CITY OF ALBUQUERQUE

**Re: Del Norte Baptist Church
5800 Montgomery Blvd. NE
Grading & Drainage Plan Engineer's Stamp Dated 8/1/17
(G18D010)**

DRAINAGE AND TRANSPORTATION INFORMATION SHEET (REV 09/2015)

Project Title: Del Norte Baptist Church repave project **Building Permit #:** _____ **City Drainage #:** G18-D010
DRB#: _____ **EPC#:** _____ **Work Order#:** _____
Legal Description: tract b and lot c2b unit 6 alta mont addition
City Address: 5800 Montgomery NE

Project No. 21635
 Drawn By: WCW
 Checked By: ds
 Date: 05.26.2017
 Sheet No. C103

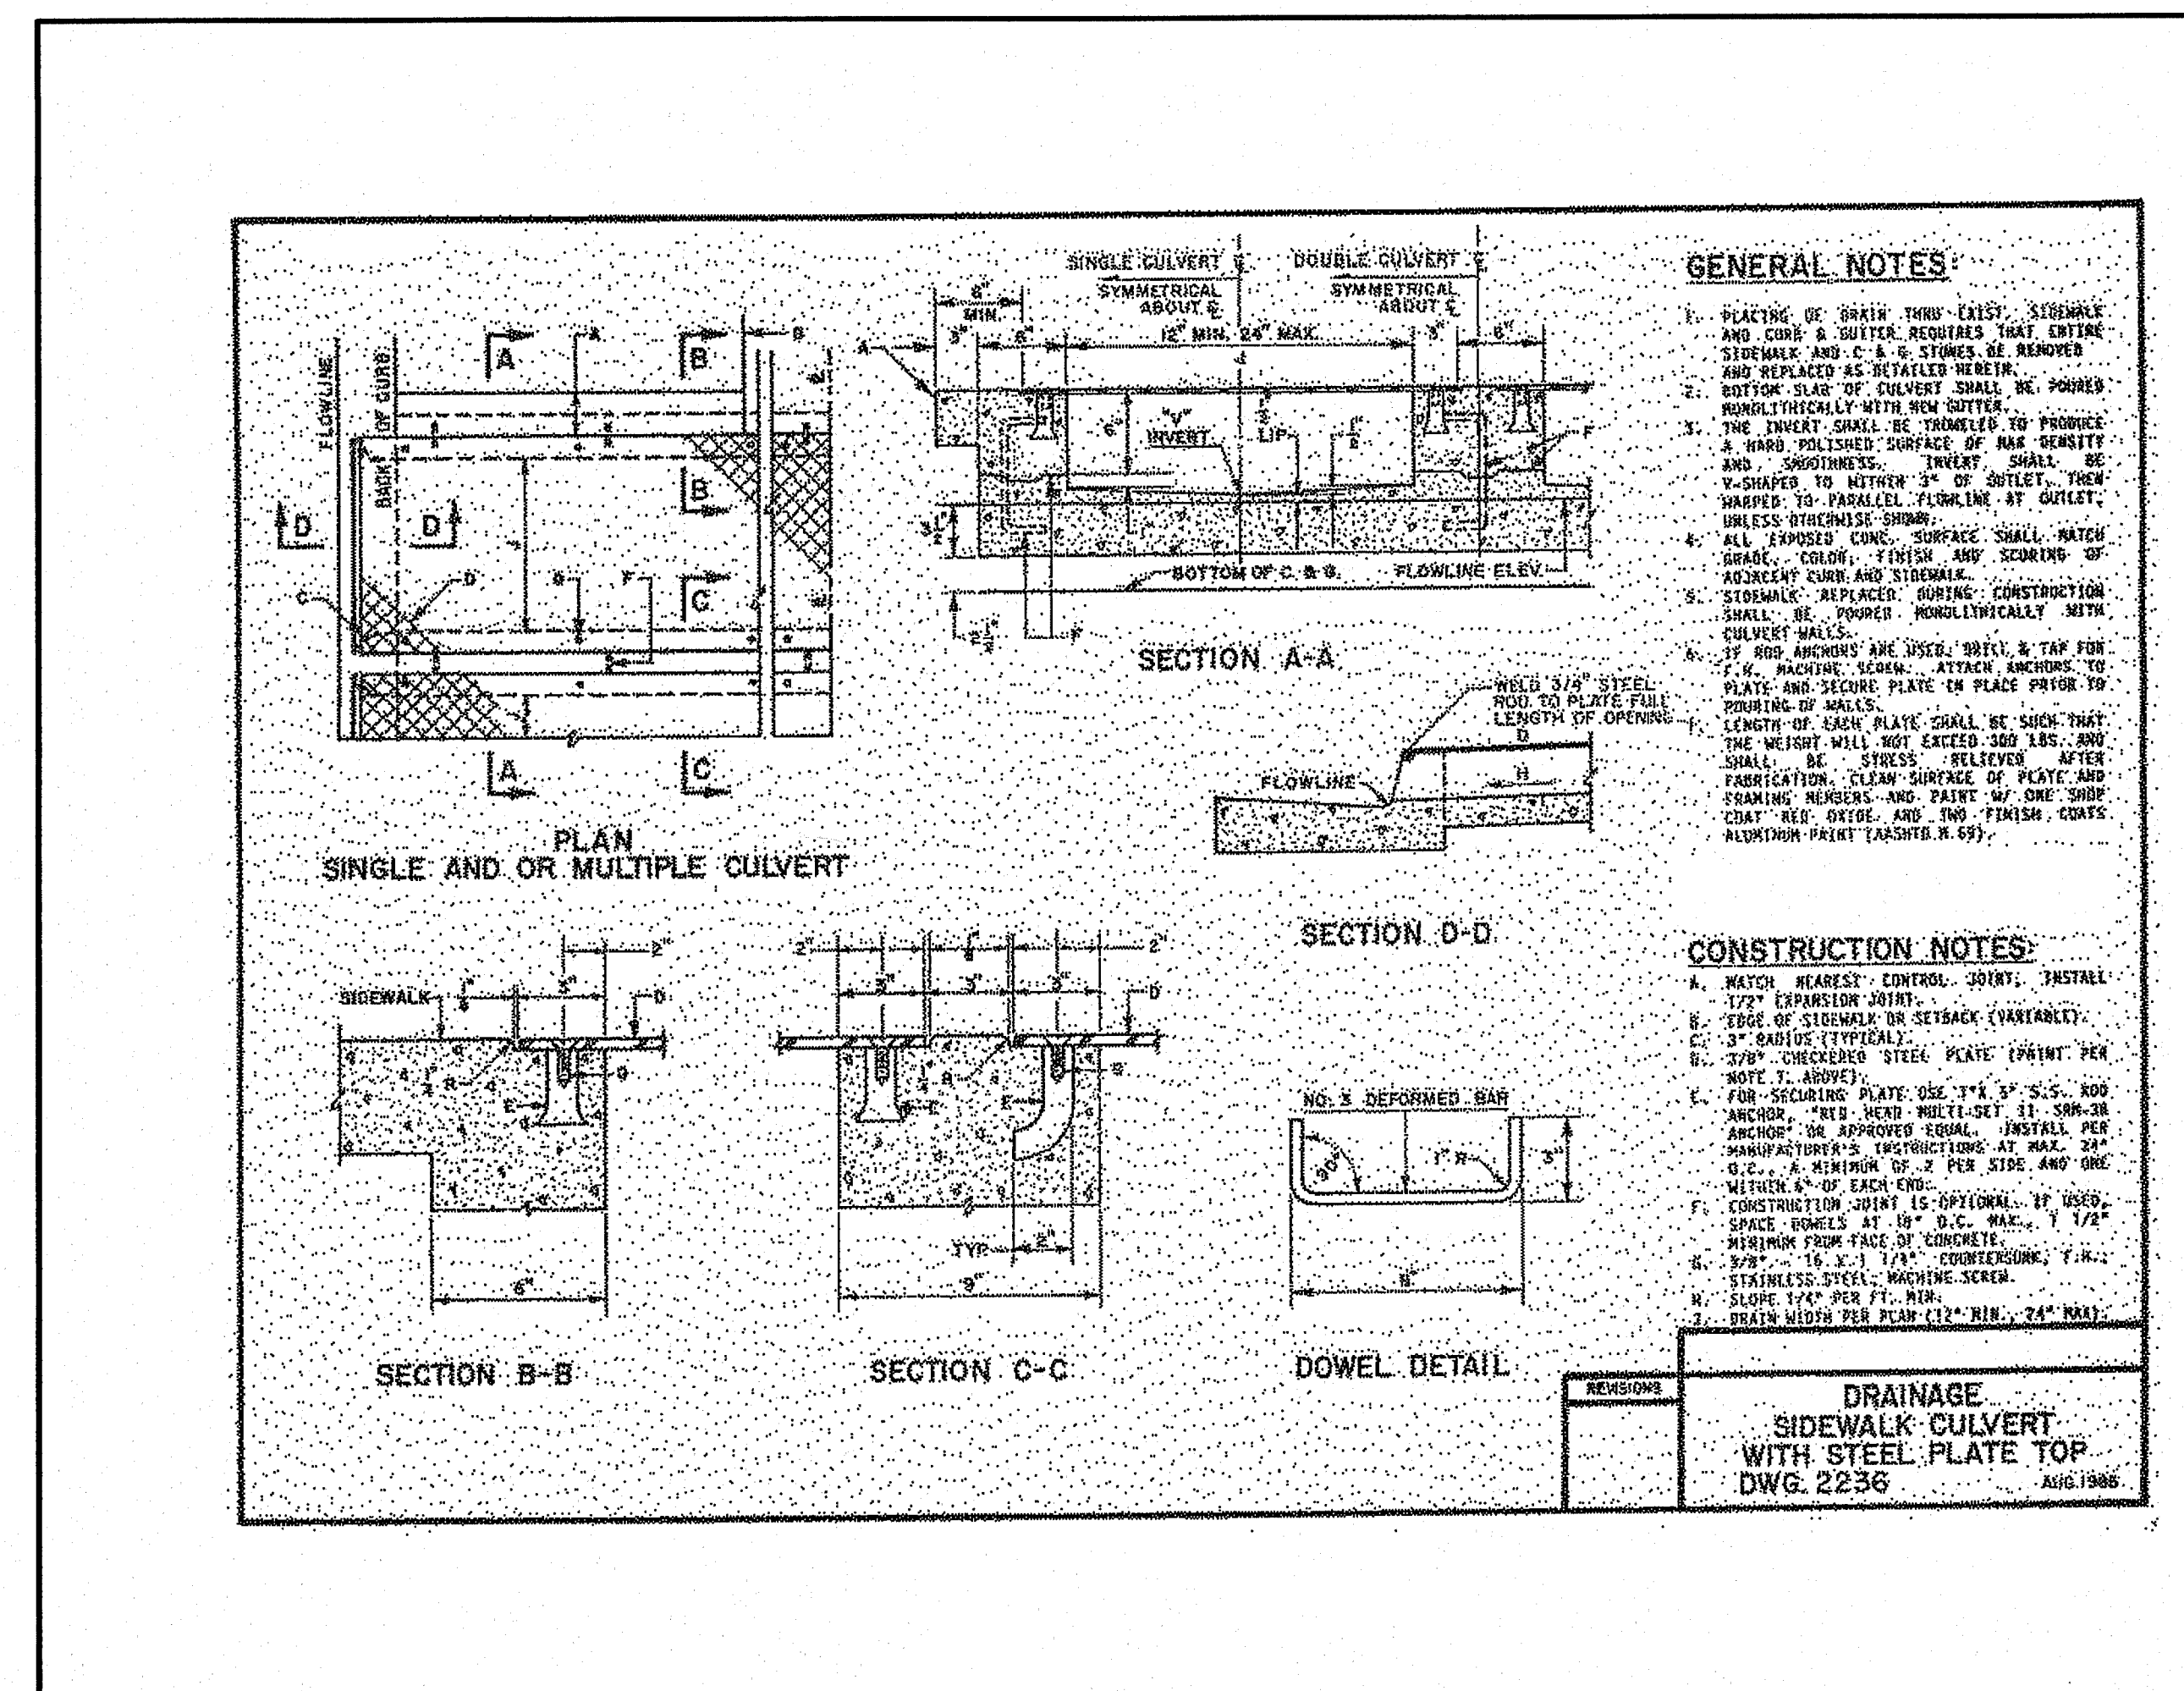
- Provide HGL calculations for onsite storm drain and add profile of pipe to the plans showing HGL and label HGL elevations, Q, and V. **ADDED**
 - Provide actual flow depth & elevation at inlets. Add emergency overflow depth & elevation calculations for sump inlets and verify freeboard to building floor elevations. **ADDED TO INLET CALCULATION SHEET**

DROP INLET CALCULATIONS

INLET	TYPE OF INLET	AREA (SF)	Q (CFS)	H (FT)	H ALLOW (FT)
INLET A	SINGLE	3.84	4.48	0.0587	0.37
INLET B	DOUBLE	7.68	5.9	0.0255	0.75

INLET A EMERGENCY OVERFLOWS TO INLET B@5243.00(AT CROSS WALK)

INLET B EMERGENCY OVERFLOWS TO SOUTH AT CURB FLOW LINE@5242.85
